Fakir Knitwears Ltd. (Extension)

Kayempur, Fatullah, Narayanganj

22 August 2023

Executive Summary

Source of loading: Chiller

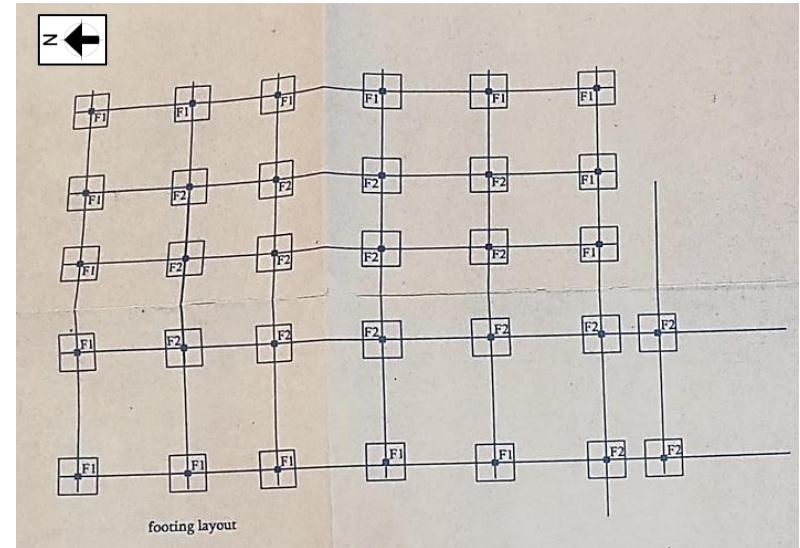
High stress in the column

Cursory calculation indicates that the marked columns are highly stressed based on 3 kPa typical floor live load, and observed machinery loads with minimum concrete (14.1 MPa) and rebar strength (415 MPa). The source of loadings are chiller machine of the floors and cooling tower on the roof. The building engineer is required to carry out Detail Engineering Assessment (DEA) to review the design, loads and column stress based on in-situ material strength, actual machinery loads and minimum floor live loads.

Structural System : Building-4 (Generator Building)

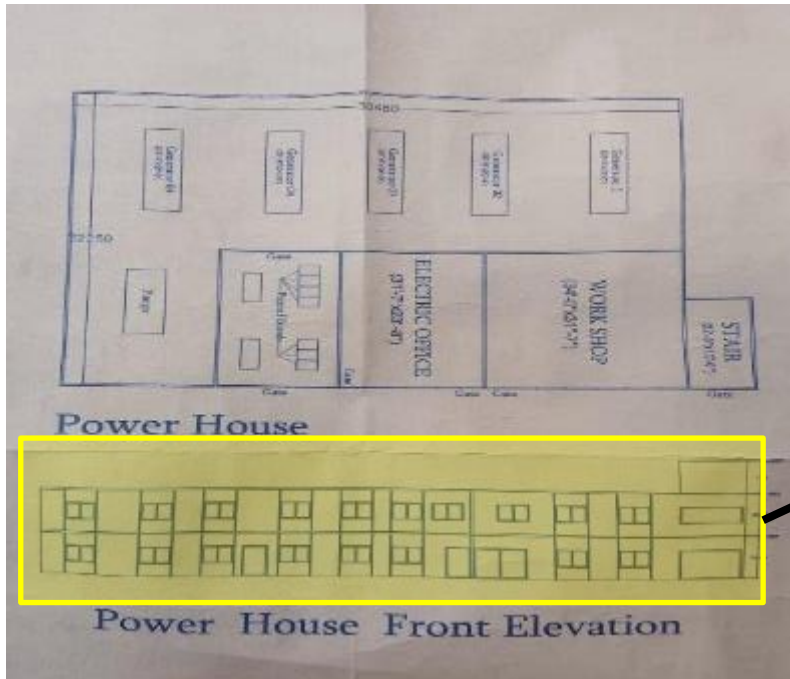
Lack of foundation details

Foundation layout drawing was available for the old part of the Building-4. But foundation size and other details were not available. In addition, geotechnical investigation report was not available for both part. However, as part of DEA, the building engineer is required to prepare as-built drawings for foundations with necessary details; carry out geotechnical investigation; check the foundation adequacy of the building and suggest proper remedial actions.

Heavy loading on roof

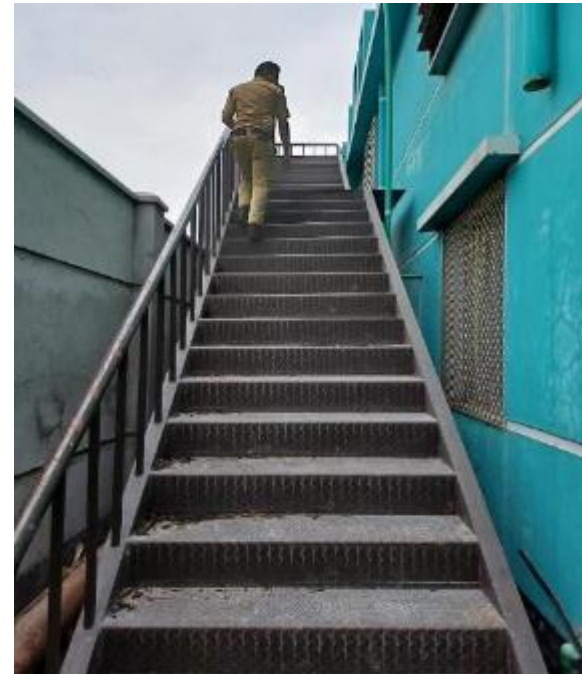
Heavy loading on roof

Building engineer is required to produce a floor load plan based on floor and column capacity of the building.

Roof layout plan: Plastic water tank not shown

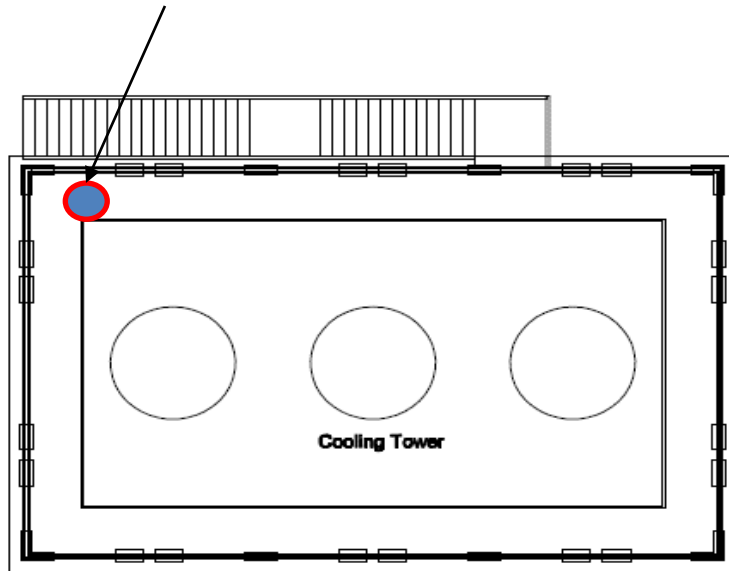
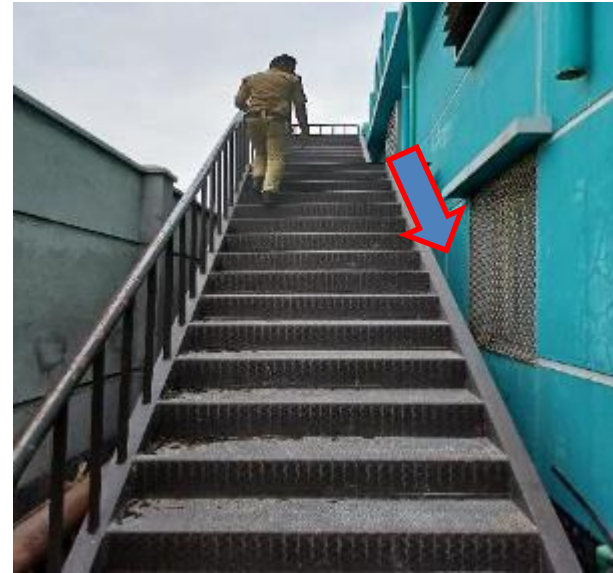
Discrepancies in as-built drawing

Plastic water tank was not shown in architectural drawing. Building engineer is required to revise the drawings as per site condition.

Falling hazard

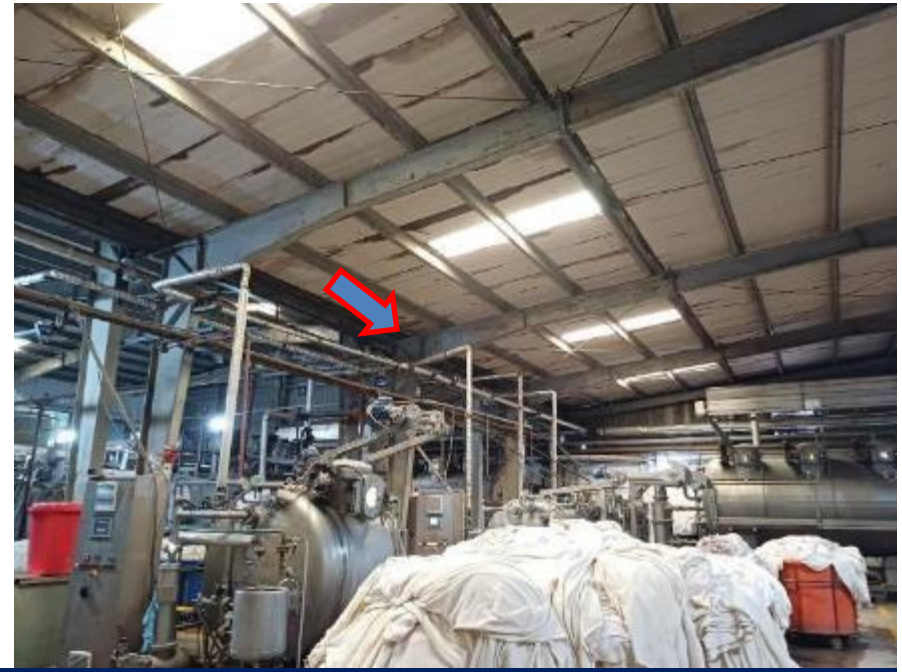
Falling hazard at mezzanine floor due to low height masonry wall

During inspection low height masonry wall found at the window area. The factory is required to provide adequate protection to avoid falling hazard.

Structural connection between Shed-9 & Shed-10

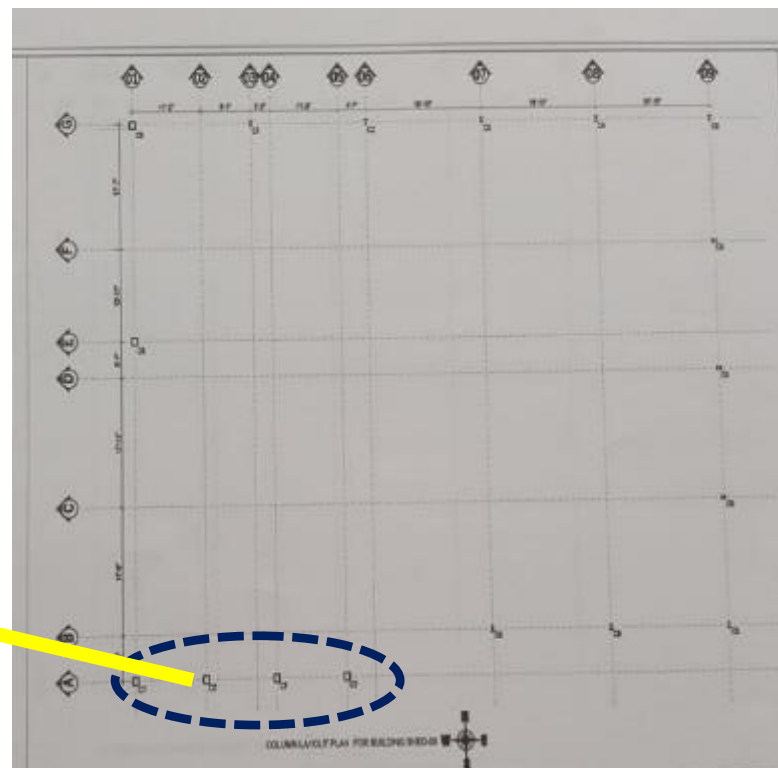
Connected portion of shed-9 with shed-10: The RC column is common for both sheds

Structural connection was observed between shed-9 and shed-10 which was not shown in drawing. Steel rafters of Shed-9 are resting on steel jack beam which is supported by a corbel of common RC column shared by both Shed-9 and Shed-10. Building engineer is required to either separate the structures or analyze the two structures as one.

Structural connection of Shed-10 with adjacent Shed-3 & Shed-9

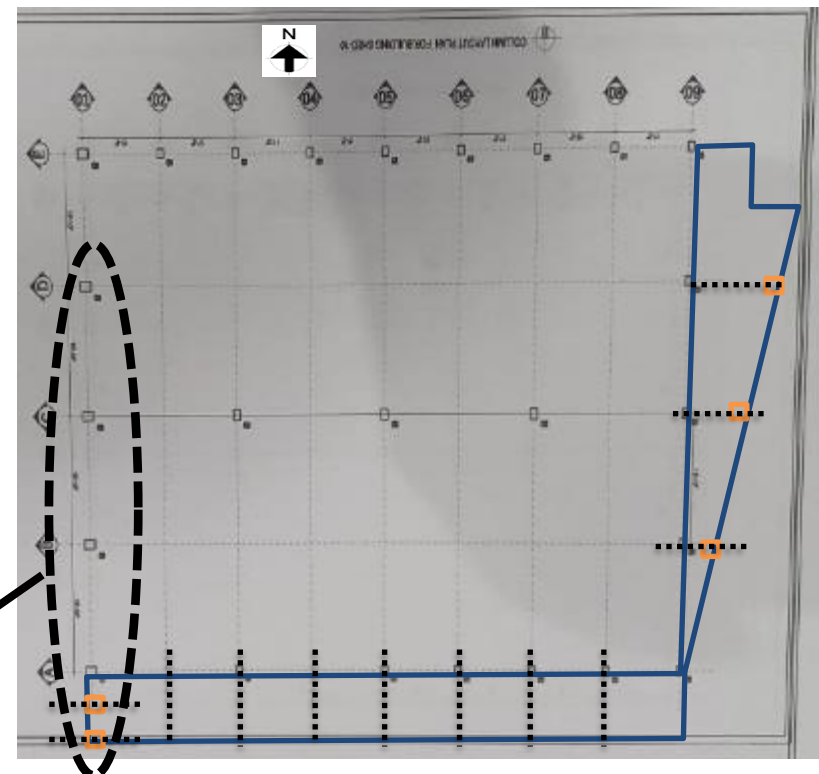
During inspection connection between shed-3 and shed-10 observed which was not shown in the drawing. Steel truss of Shed-10 connected with RC column of Shed-3. The building engineer is required to survey the structures and update the as-built drawing with structural connection details. Also, revise the design documents considering structural connection of the structures.

Connected portion of shed-9 with shed-10: The RC column is common for both sheds

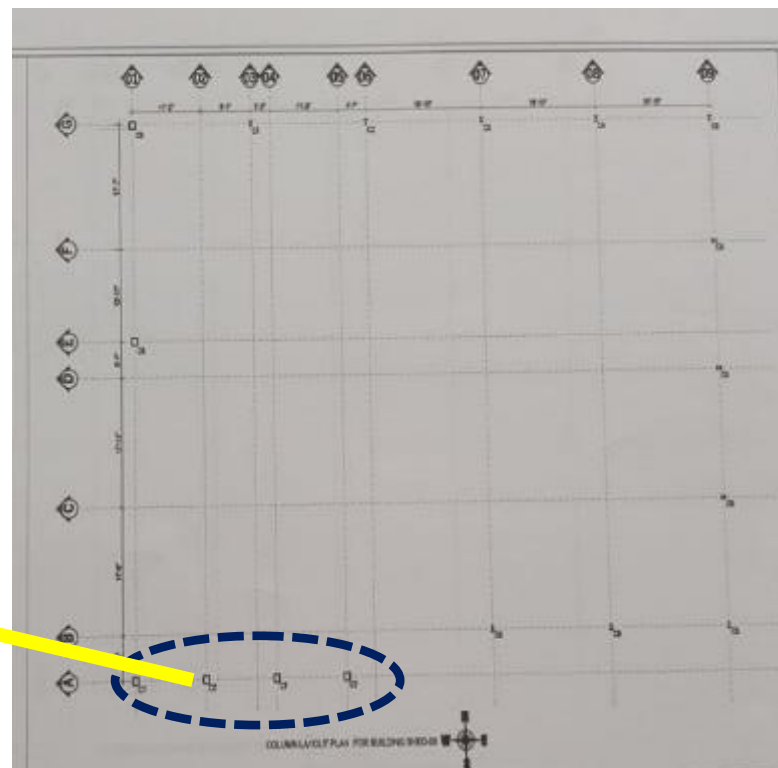
During inspection connection between shed-9 and shed-10 observed which was not shown in the drawing. Steel rafter of Shed-9 rested steel jack beam which is supported by corbel of common RC column. The building engineer is required to survey the structures and update the as-built drawing with structural connection details. Also, revise the design documents considering structural connection of the structures.

Lack of lateral stability

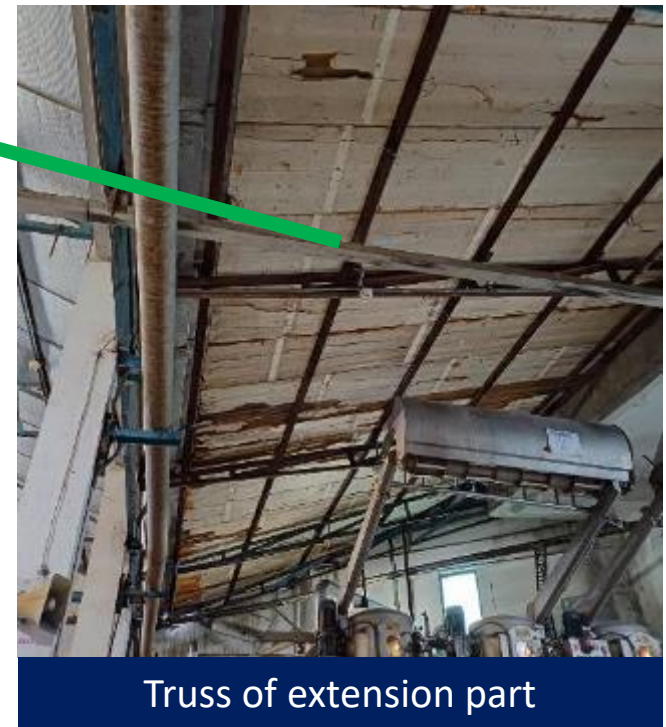
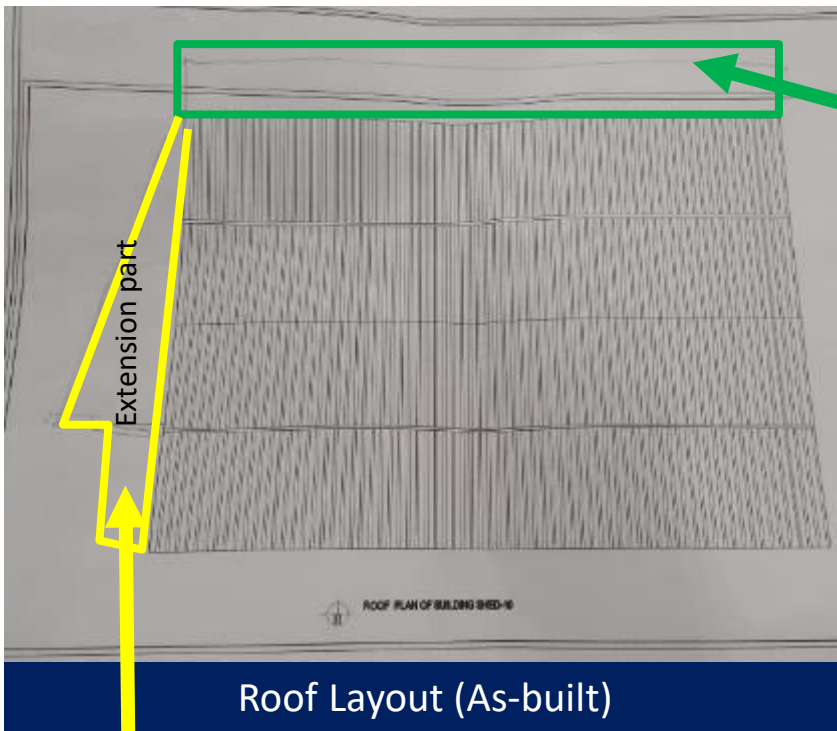
No bracing system/compression member is provided

No bracing/compression member is provided for the shed therefore the lateral stability system is absent for the structure. Building engineer is required to check the lateral stability of the shed as part of EA and suggest proper remedial work.

Discrepancy in as-built drawing

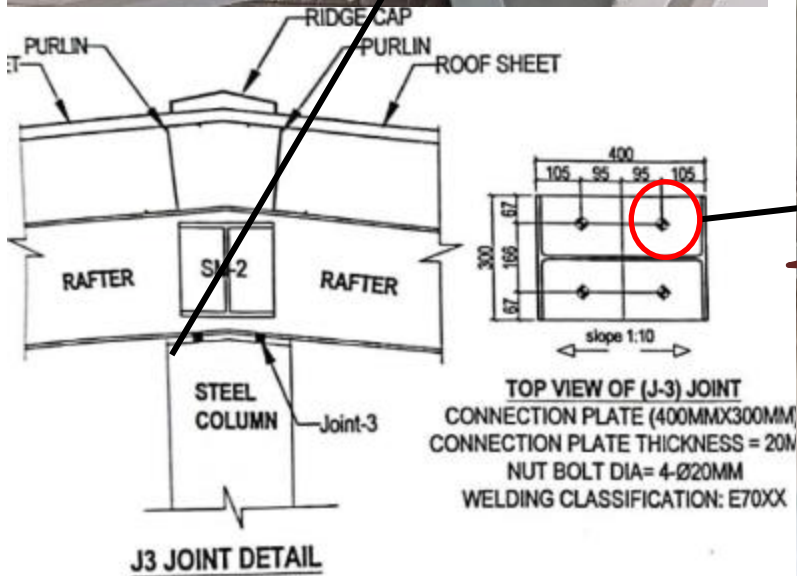
Bracings connected apart from column-rafter joint

As per drawing bracings are supposed to be connected in the column-rafter joint but bracings were connected apart from the column-rafter joint. The building engineer is required to check the bracing connections and update the as-built drawing accordingly. Also, revise the analysis as per onsite condition.

Shed-15

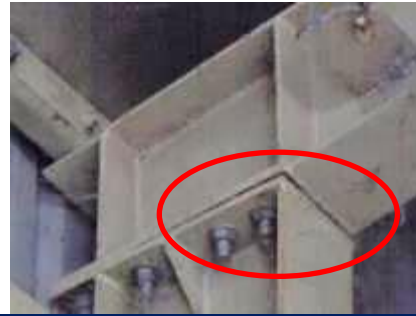
As-built drawing was not found on-site which is required to be prepared.
